**NSLPP MEETING HELD ON 01/06/2022
SECTION 4.55 APPLICATION REPORT**

ADDRESS/WARD: 34 Phillips Street, Neutral Bay

APPLICATION No: DA 141/21/3

PROPOSAL: Section 4.55(2) to modify development consent DA 141/21 for the demolition of an existing dwelling house and garage and construction of a two storey dwelling house and associated landscaping.

Figure 6 – Landscape Concept Plan – Ground Floor (L102 Rev I)

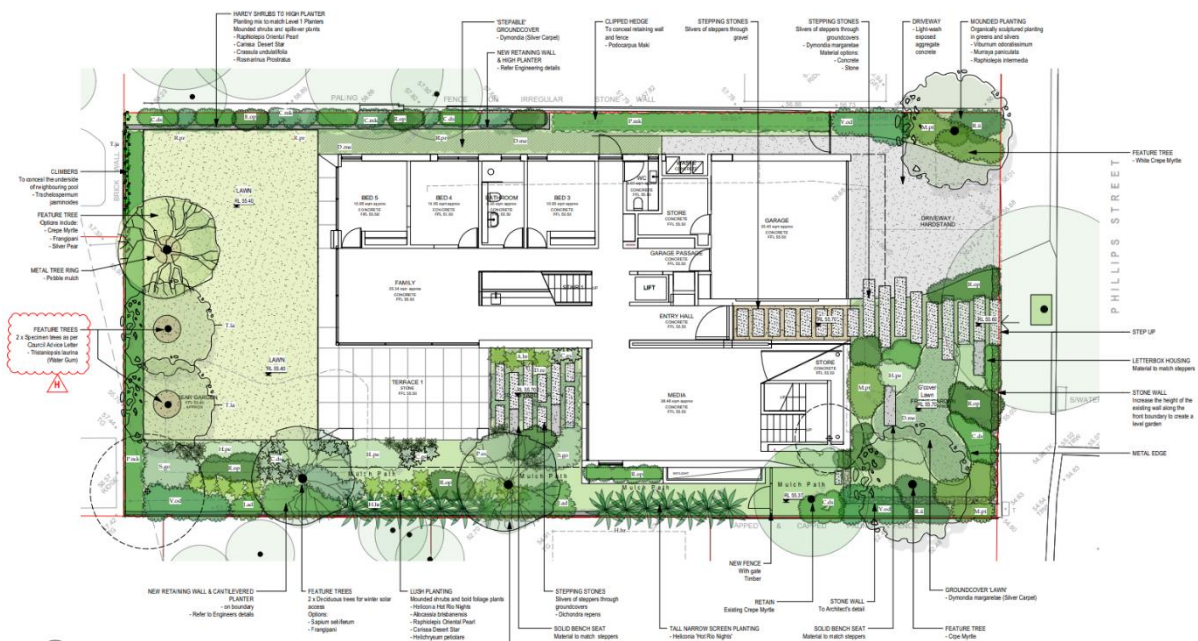
C28. The landscape plan (L102 Rev I) must be amended as follows to provide an appropriate landscaped setting:

- The front south western garden is to have a maximum RL of 55.40 as stipulated in the Ground Floor Plan (455.04 Rev B). No modification or alteration to existing soil levels within the Tree Protection Zone of the Jacaranda mimosifolia shall occur.

Figure 11 – Basement Plan (455.05 Rev C)

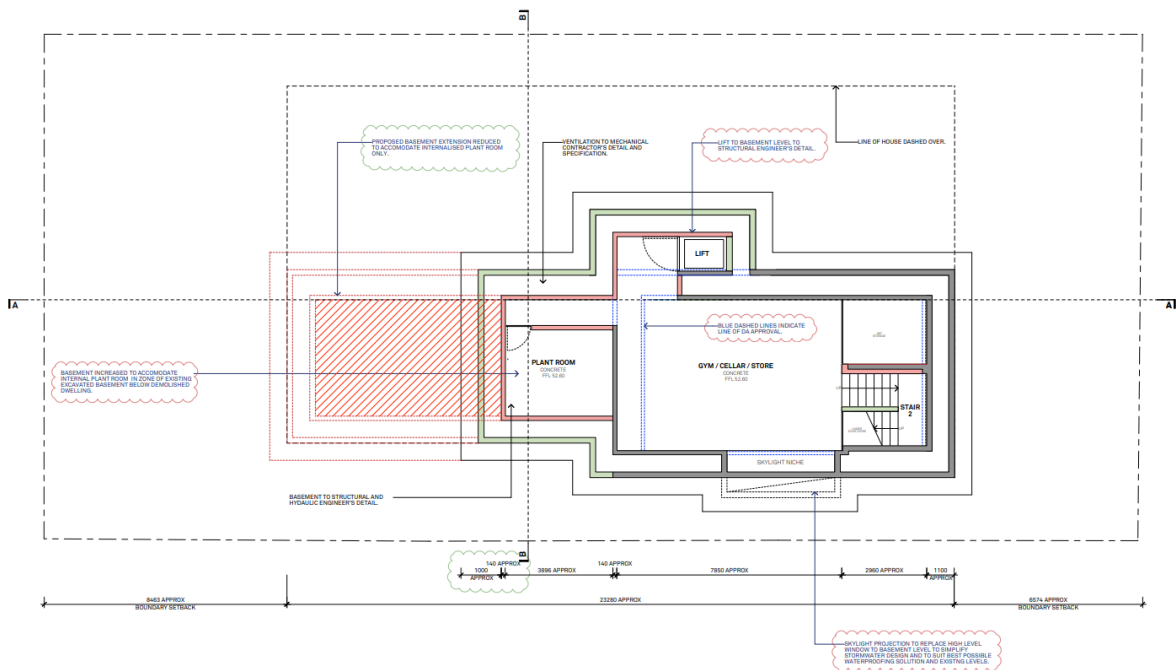
The proposed basement as shown in the Dwg No. 455.05 Rev C has been assessed against the matters for consideration in Cl. 6.10(3) Earthworks of NSLEP 2013 and is considered acceptable, noting the basement is located directly under the footprint of the dwelling, having no impact on the natural features of the site, including landscaping on the site and adjoining land. The earthworks for the proposed enlarged basement have no effect on the future redevelopment of the land and is unlikely to have an adverse effect on the amenity of the adjoining properties because the basement is set back 2.2m from the western side boundary and 6.1m from the eastern side boundary. Conditions of consent outlined in the original development consent included requirements for a dilapidation report concerning excavation and a geotechnical report ensuring the structural integrity of the subject site and adjoining sites to withstand excavation.

Figure 15 – Proposed Northern Elevation (455.08 B) with annotations detailing required soil depths recommended by Spirit Level Designs Pty Ltd

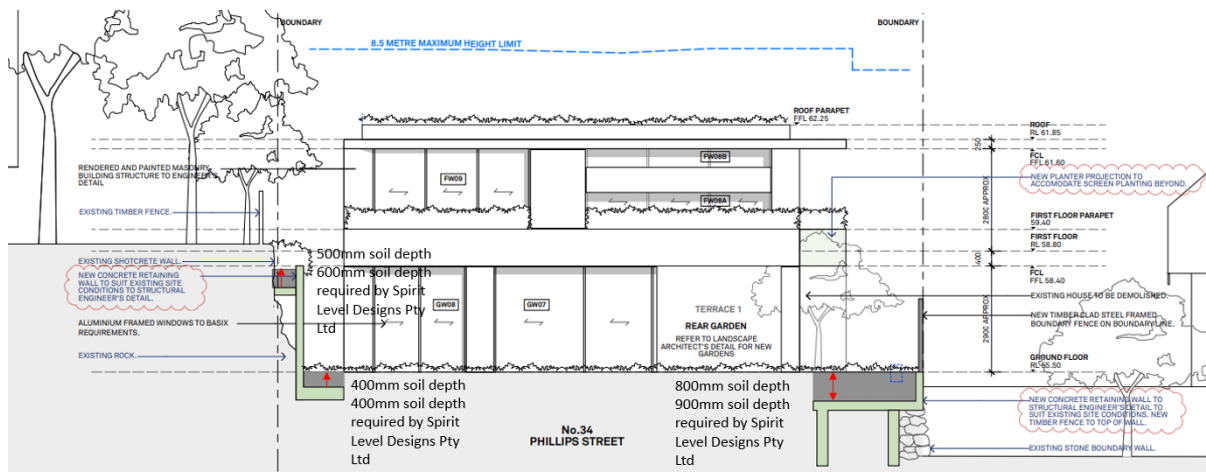
The applicant provided supplementary information by Partridge Structural Pty Ltd of the structural details of the proposed retaining walls and the landscape architect Spirit Level Designs Pty Ltd detailed the required depth of soil to support landscaping within the eastern and western side setback areas. The existing depth of soil and that required by Spirit Level Designs Pty is annotated below. A condition of consent is recommended (C30 Soil Depths) to ensure the depth of soil between the underlying footings of the retaining walls and ground level is in accordance with the requirements of the landscape architect.

In summary, the proposed increase to the size of the basement and proposed earthworks for the retaining walls are considered acceptable. The proposed excavation is unlikely to have a detrimental impact on environmental functions and processes, neighbouring uses or features of the surrounding land, subject to retention of existing conditions of consent and subject to a condition requiring appropriate soil depths to be achieved.

Figure 18 – First Floor Plan (455.03 Rev B) confirming increased width of western planter

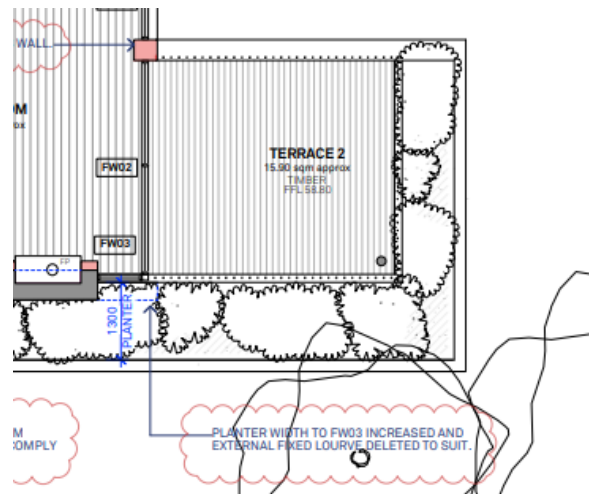
Condition C23 *First Floor Terraced Design Modification* required the first floor front terrace to be reduced in size with a greater provision of landscaping within the western planter bed. The condition required the planter bed to be increased from 800mm to 1.3m and additional native planting to be incorporated within the terrace planter.

These amendments have been incorporated to comply with the requirements of Condition C23 as shown below.

Figure 21 – Section detailing retaining wall and stone retaining wall of neighbouring property (Partridge Structural Pty Ltd)

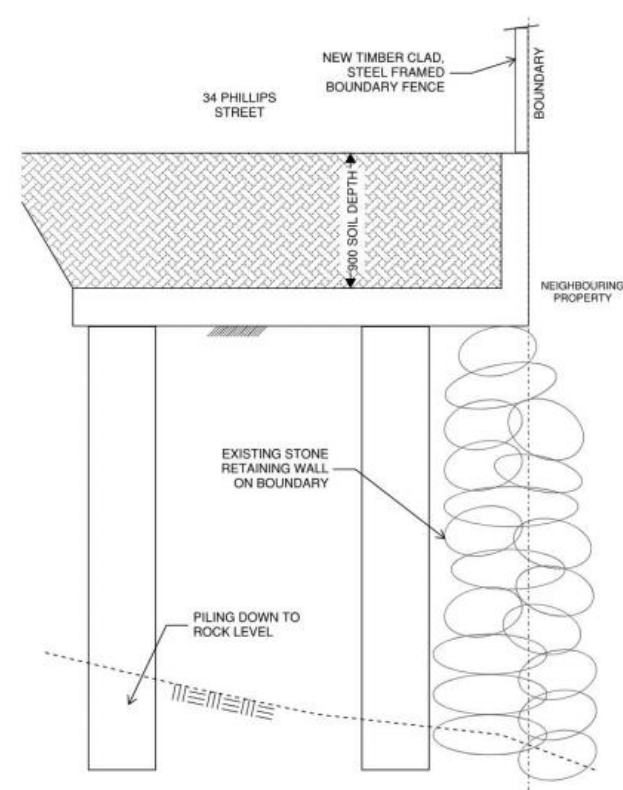
- *A retaining wall should be constructed along the entire western boundary to protect the structural adequacy of adjoining sites.*

The proposed western boundary retaining wall was recommended by Partridge Structural Pty Ltd as an engineering solution after inspecting the condition of the north western corner of the site after the demolition of the existing dwelling and swimming pool which revealed a stone retaining wall along the boundary. The retaining wall solution is sought to support the new fence as shown in the below Section.

It is considered appropriate to limit the extent of retaining walls to minimise earthworks and unbuilt upon area, where possible, and to promote landscaping including tree planting which requires greater soil depth.
